IFB No. 21-41 Fairview E.C.C. Roof Replacement

RE: **ADDENDUM NO. 5**

PROJECT NUMBER: RPS# 2126 BFA # 1121

FOR: Roof Replacement for Fairview Early Childhood Center

M-1

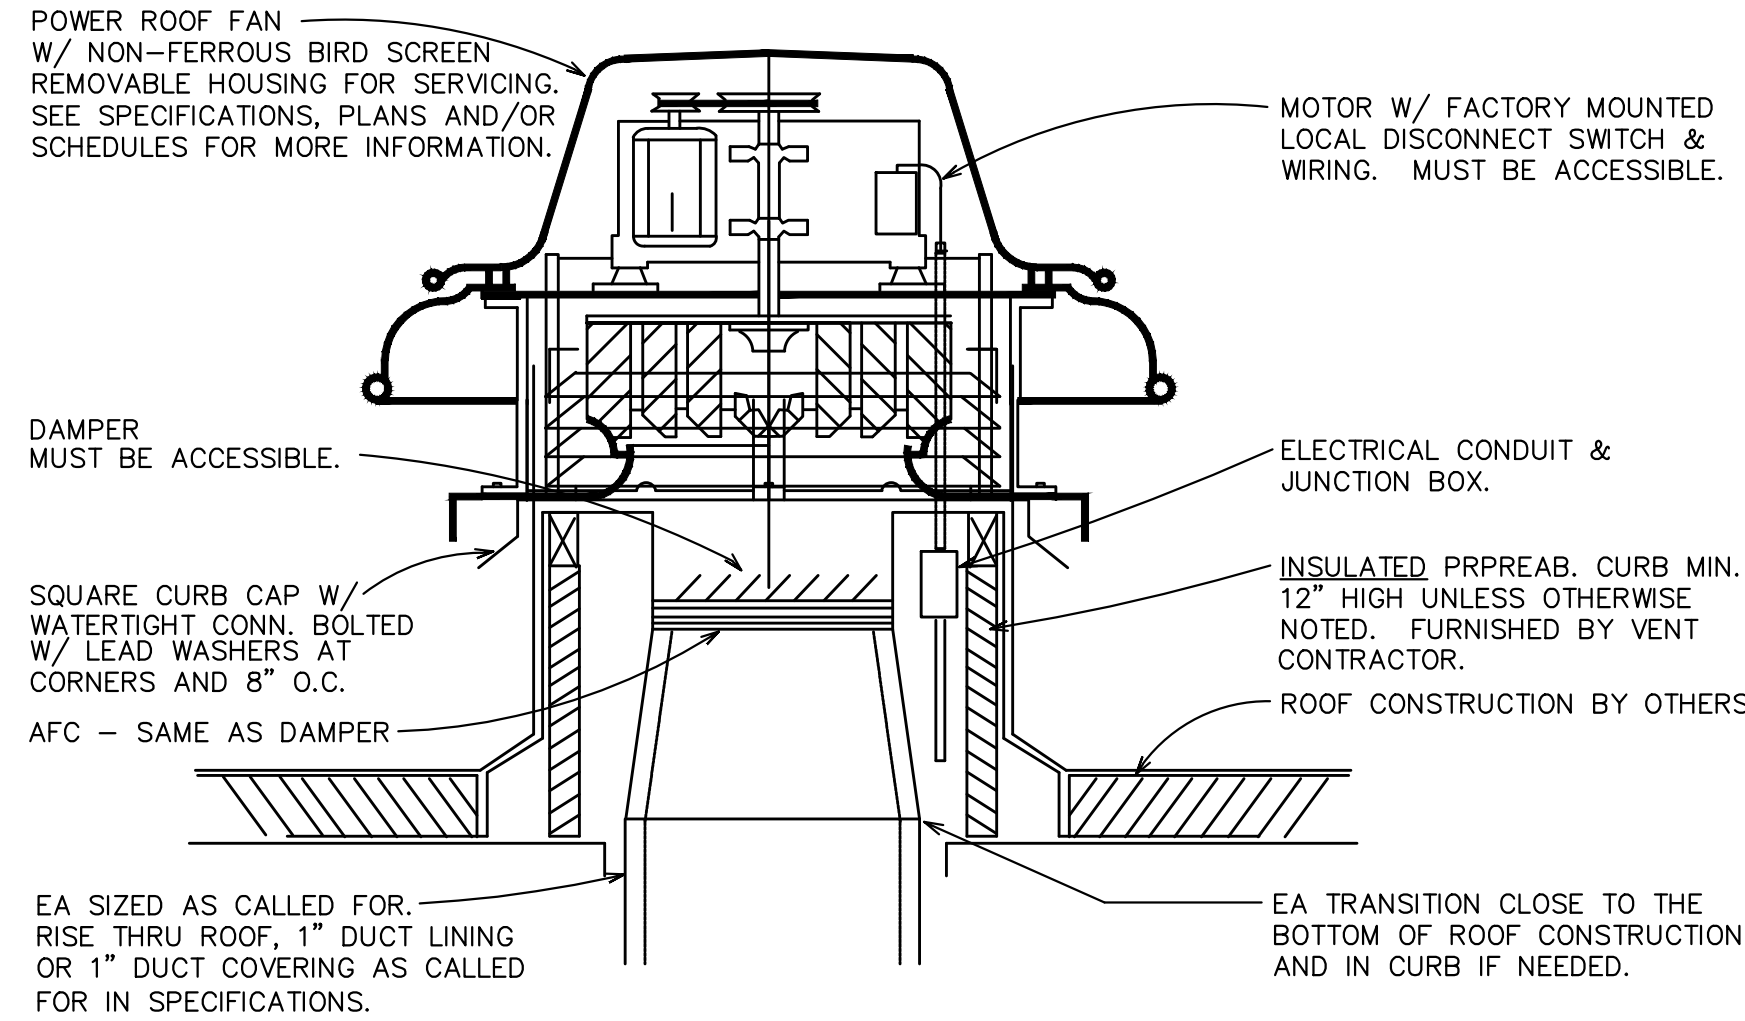
Fans were changed/added at two locations as indicated on the revised sheets.

E-1

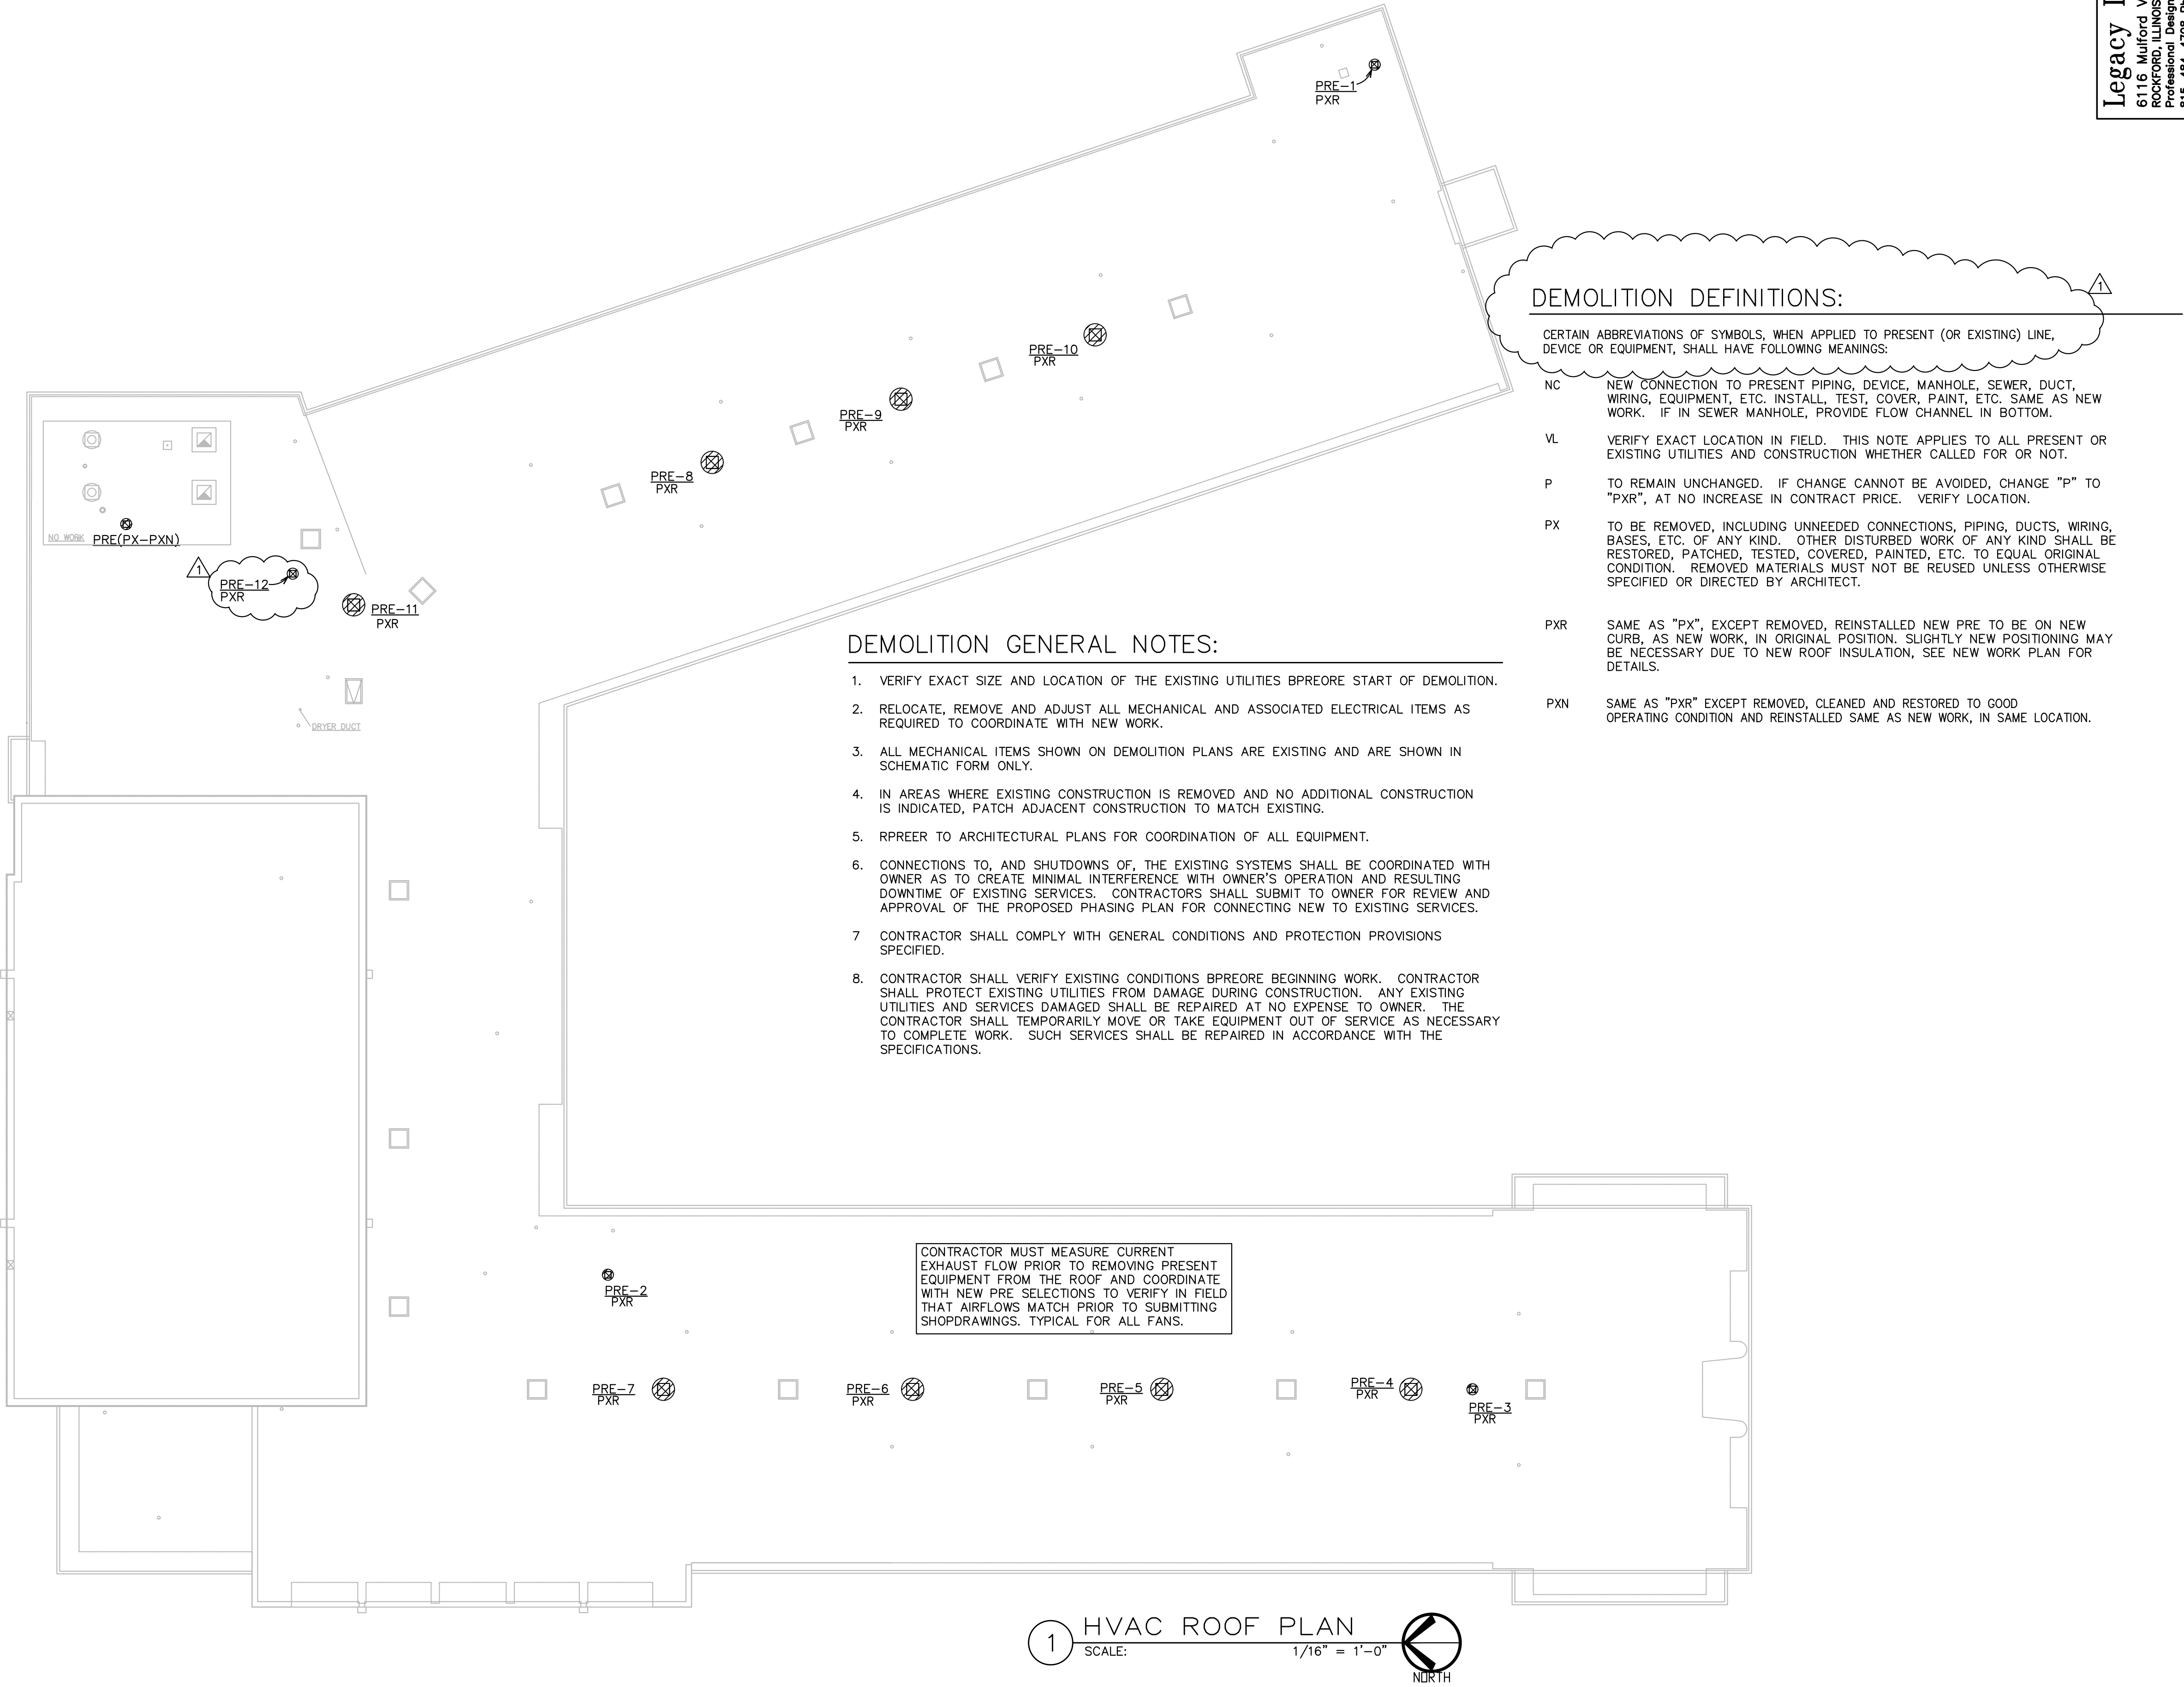
REVISED
6-4-21
REV.

1. DISCONNECT PRESENT EXHAUST FAN TO BE PRELACED AND EXTEND WIRING AS REQUIRED TO ACCOMMODATE NEW 18" CURB AND POWER CONNECTION AT EACH LOCATION.
